No.	REVISION	BY	DATE	H-SCALE 1"=300'	V-SCALE N/A	DATE 1/23/23	DESIGNED BY DJV	DRAWN BY WUL	CHECKED BY	SAND CREEK RESTORATION	GEC PLANS	SHEET 90 OF 111	JOB NO. 25188.04

SAND CREEK RESTORATION

GEC INITIAL

SHEET 109 OF 111  
JOB NO. 25188.04

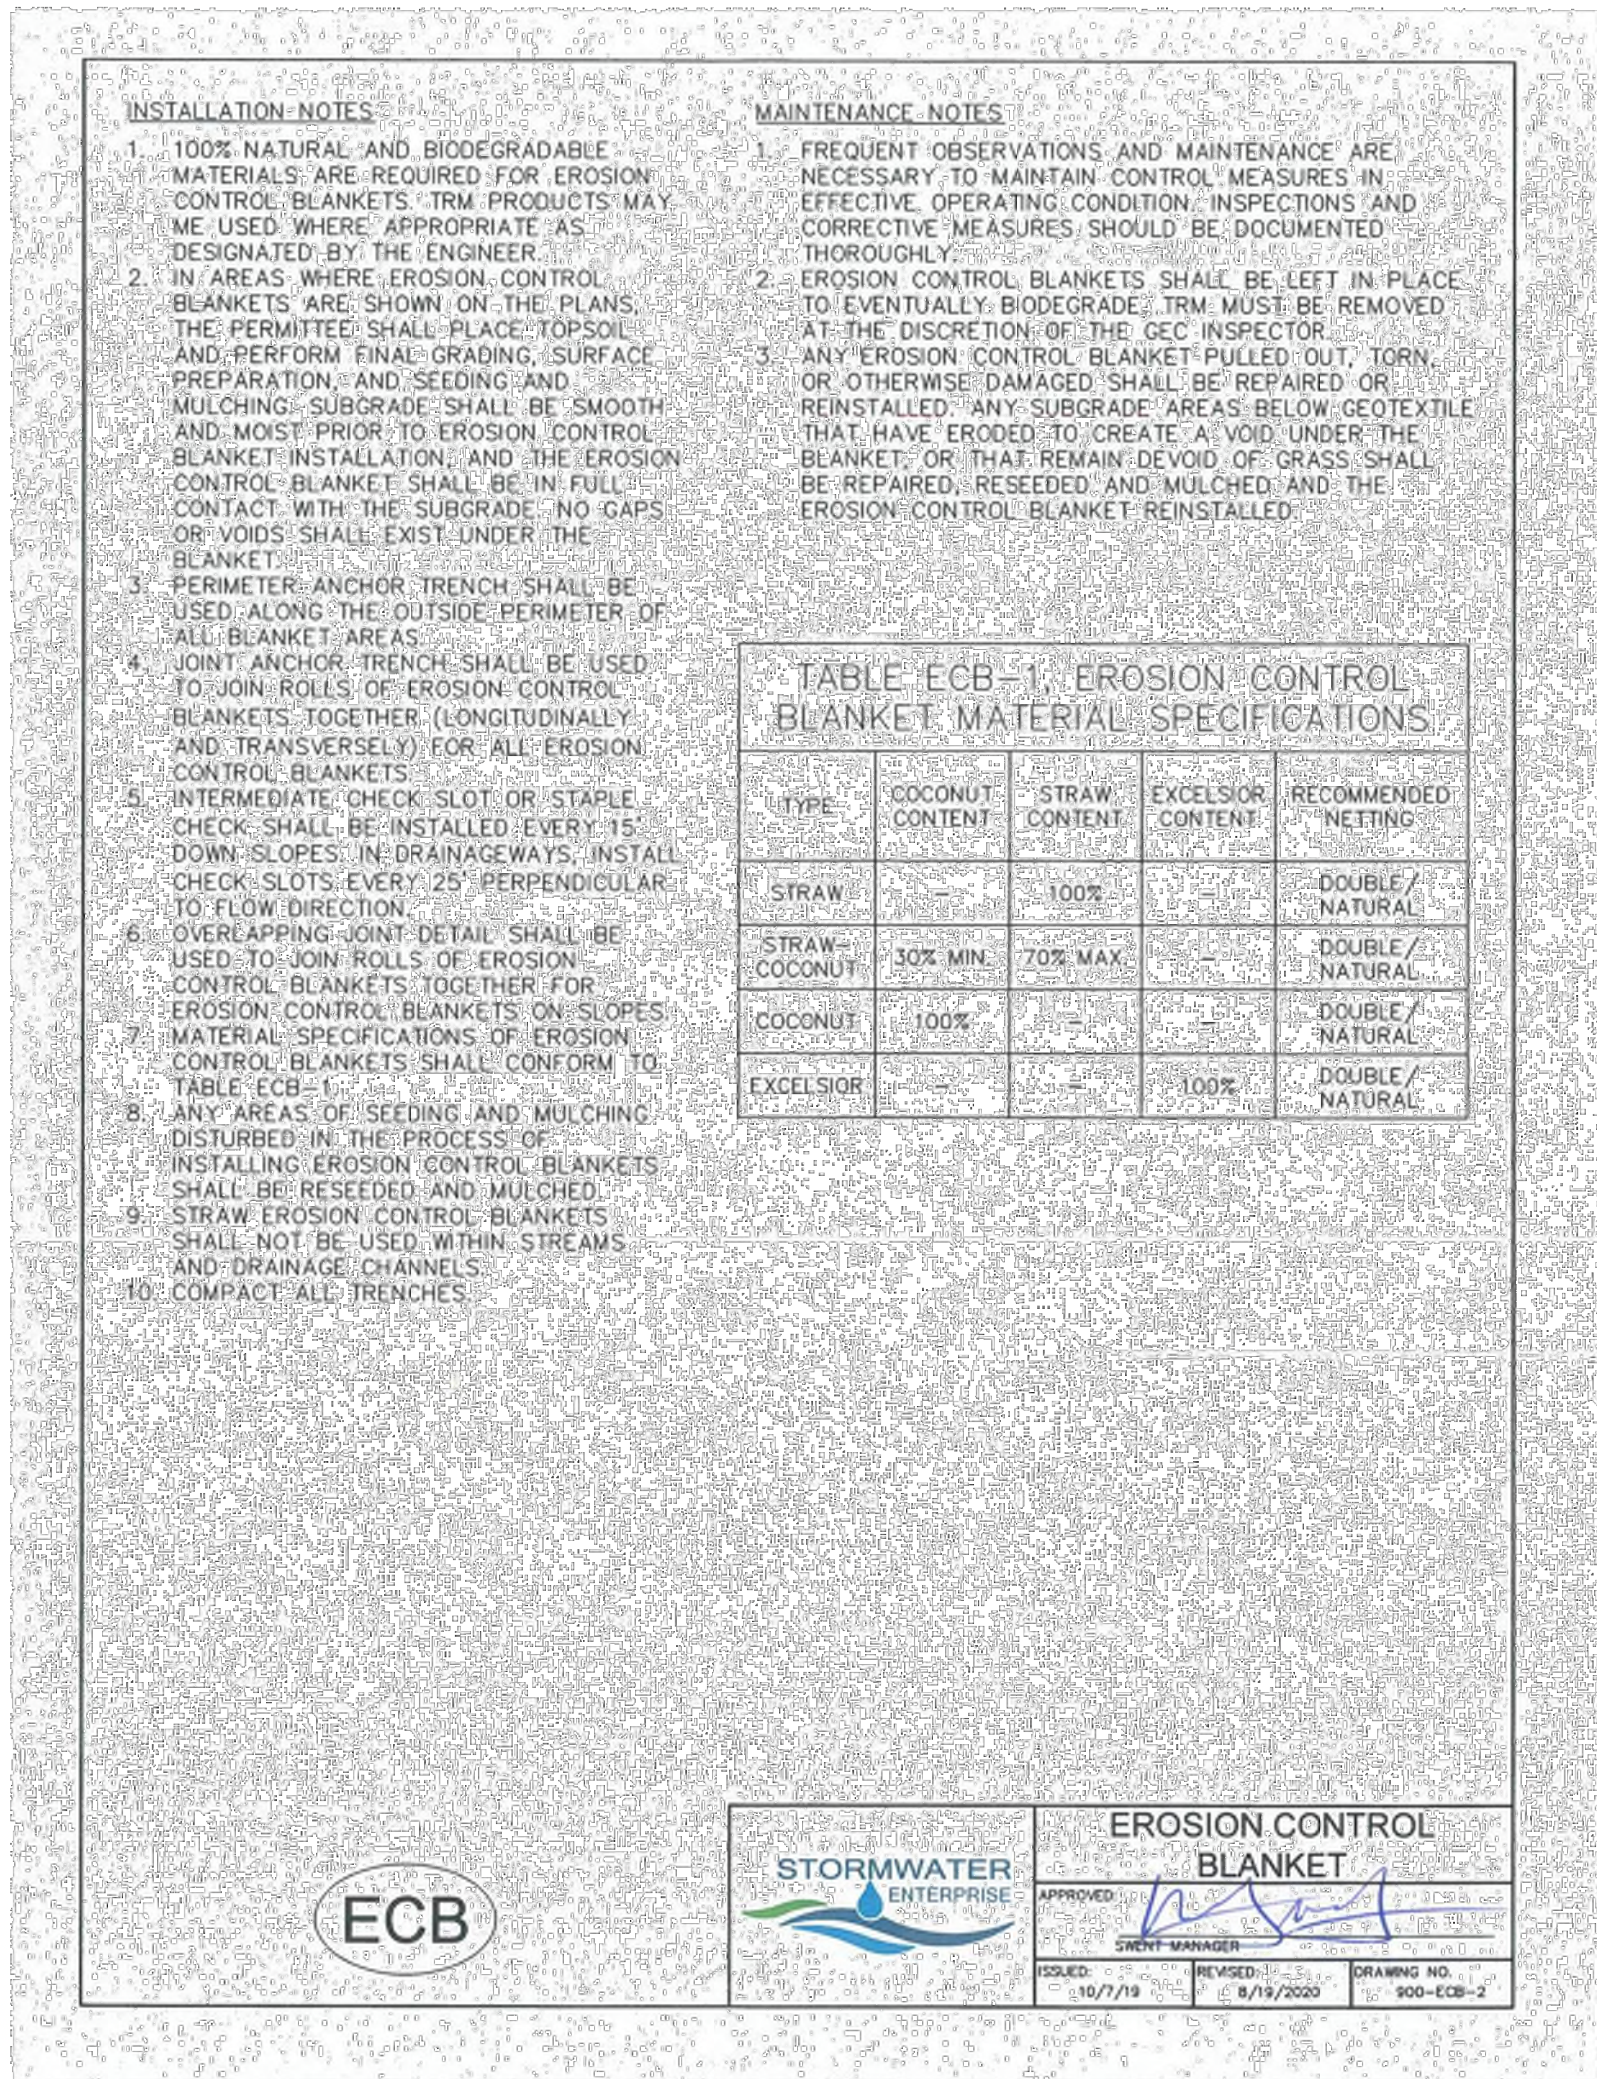
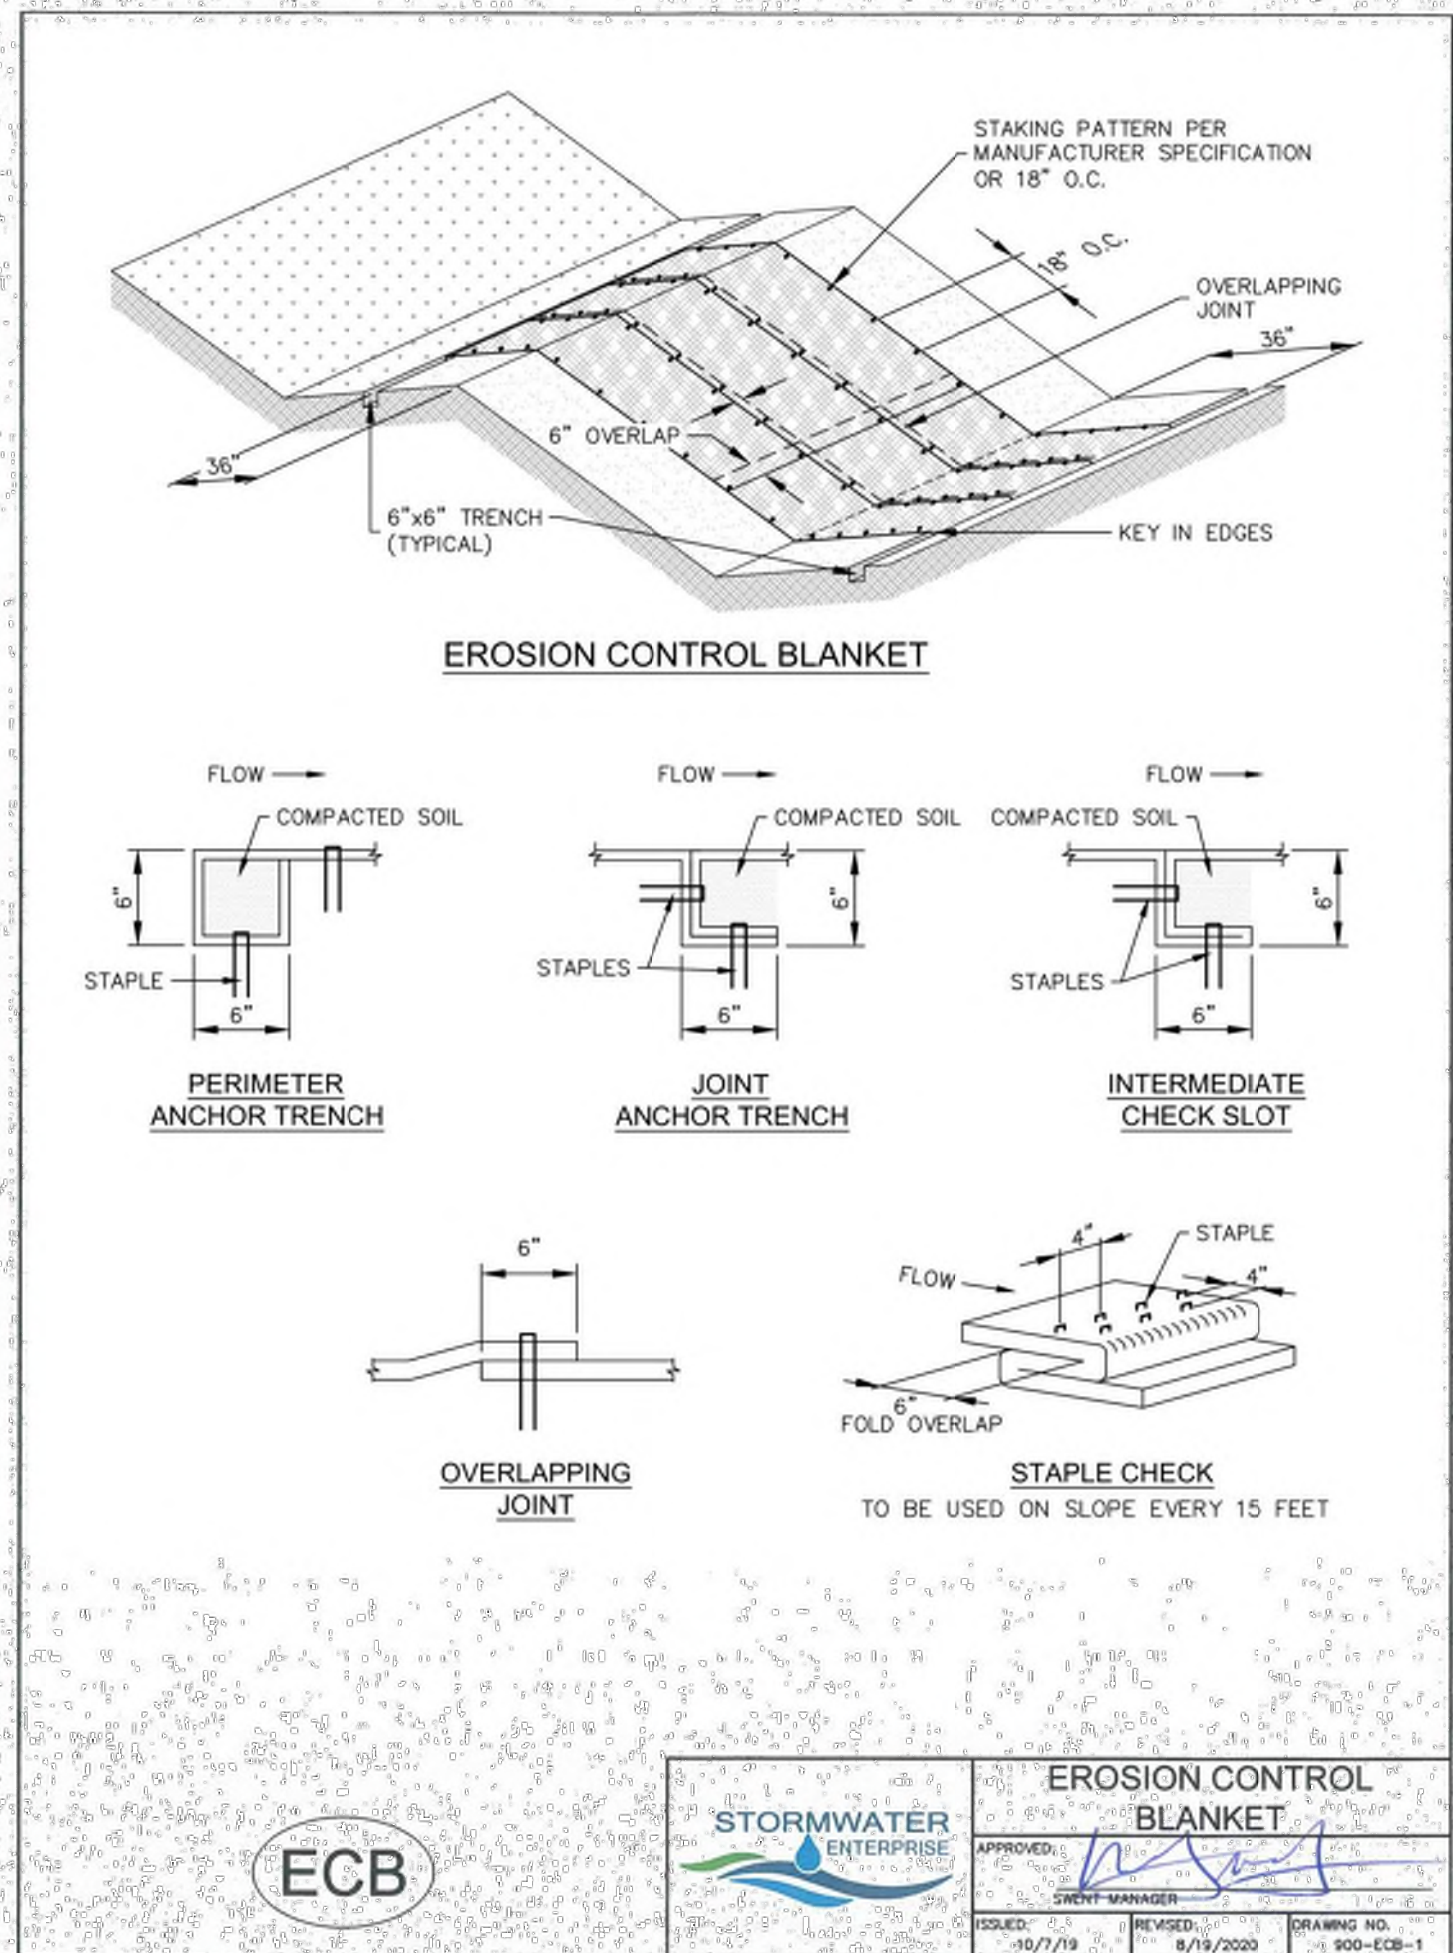
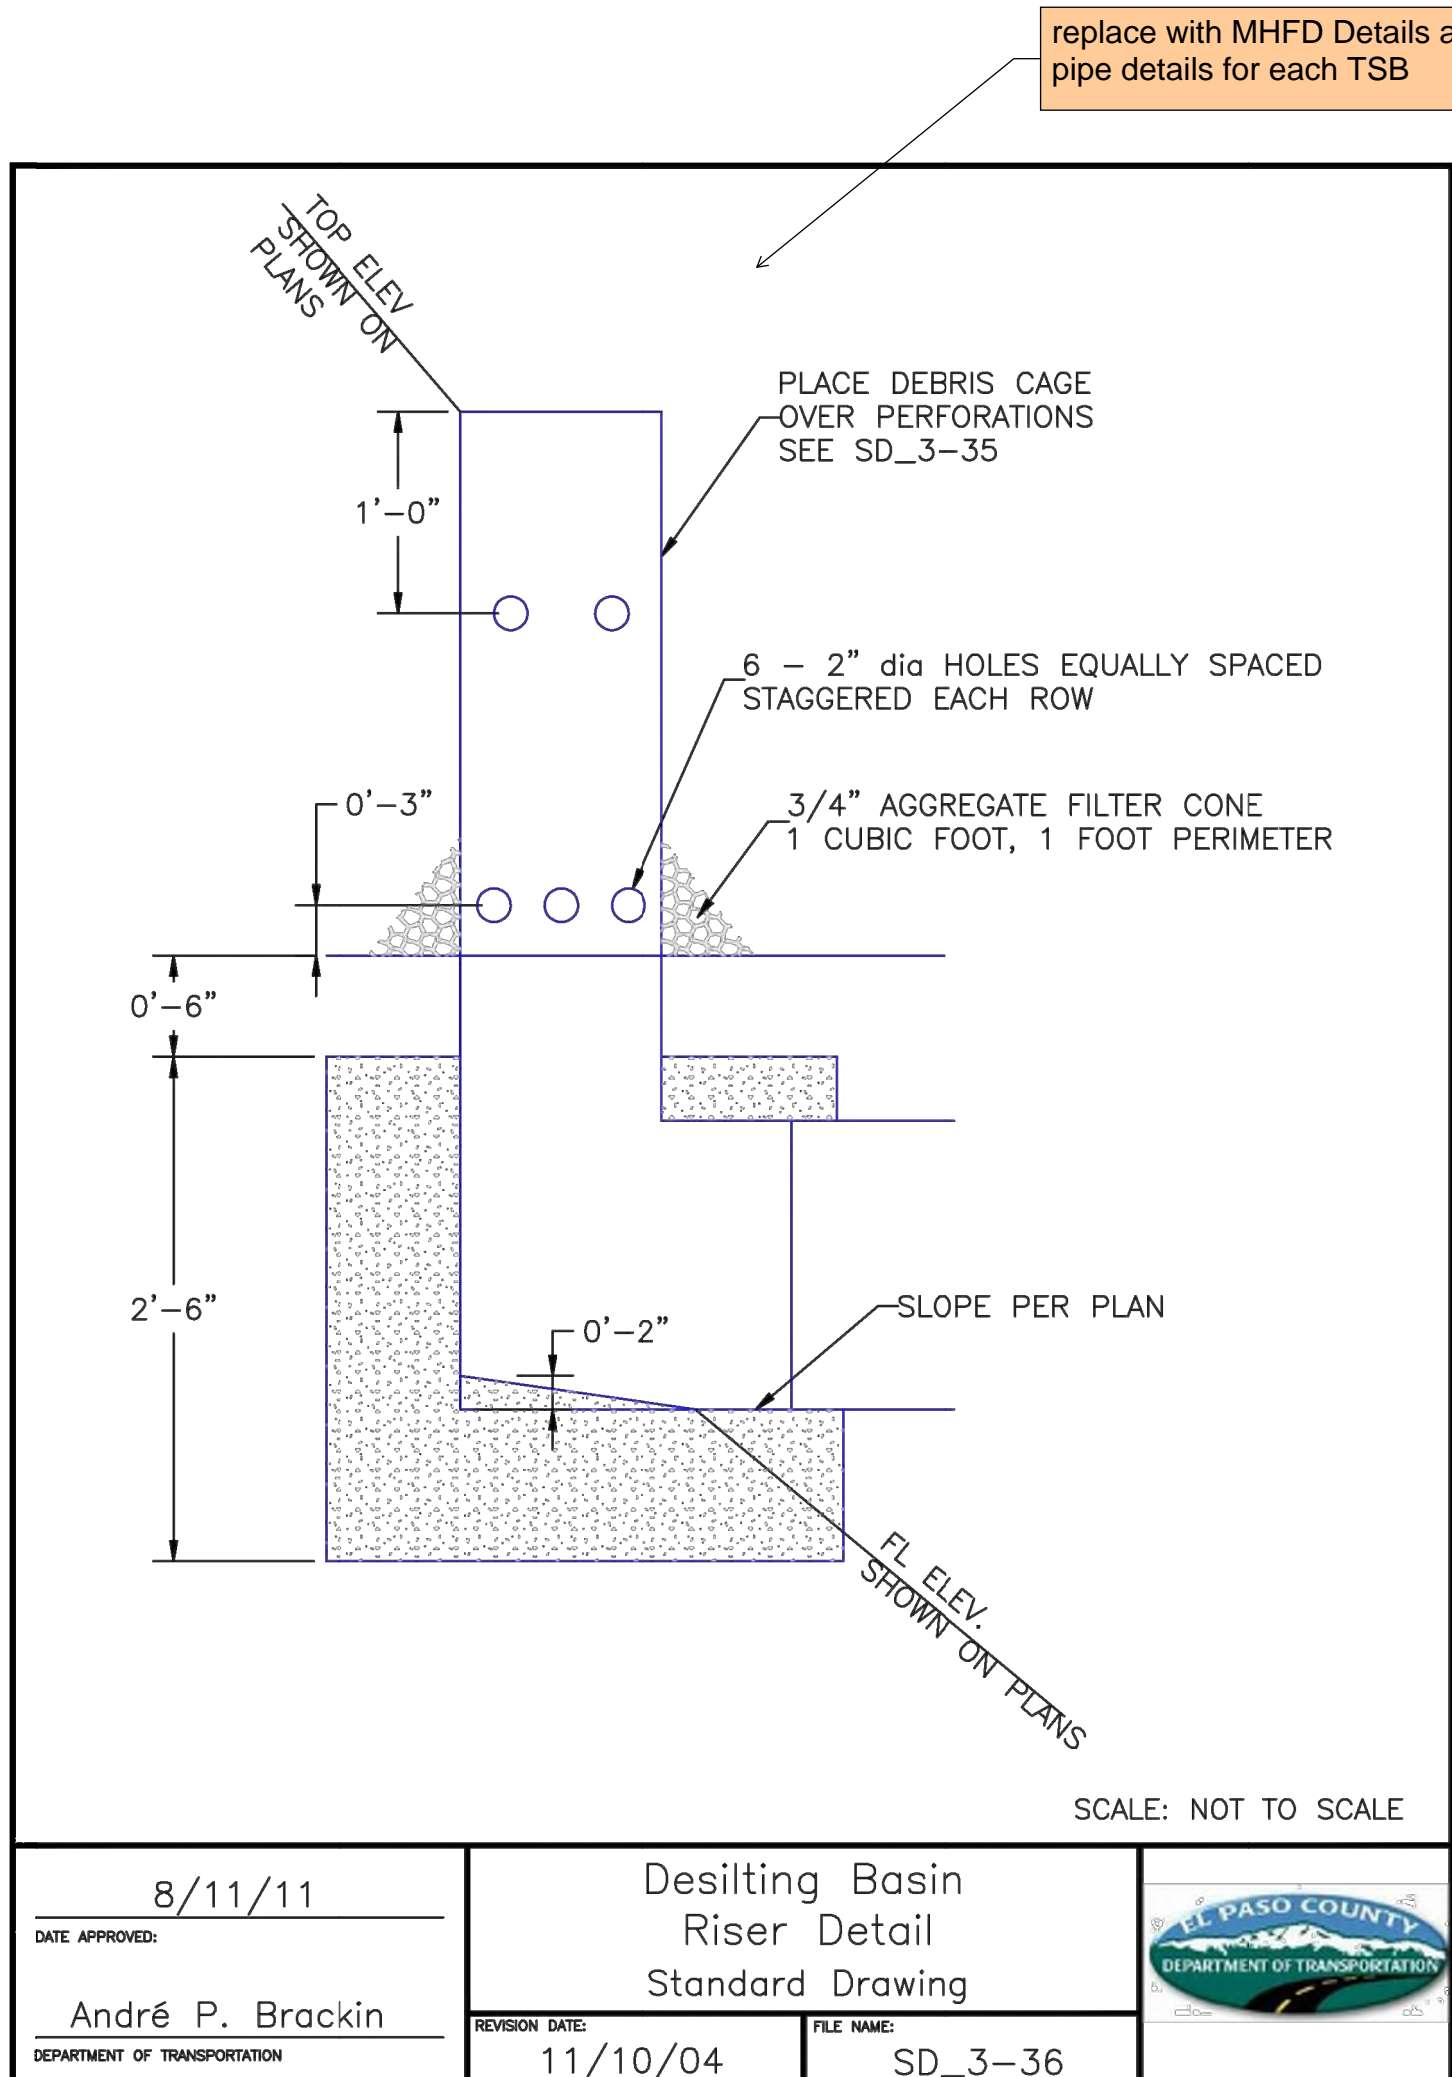
Provide channel check dam detail
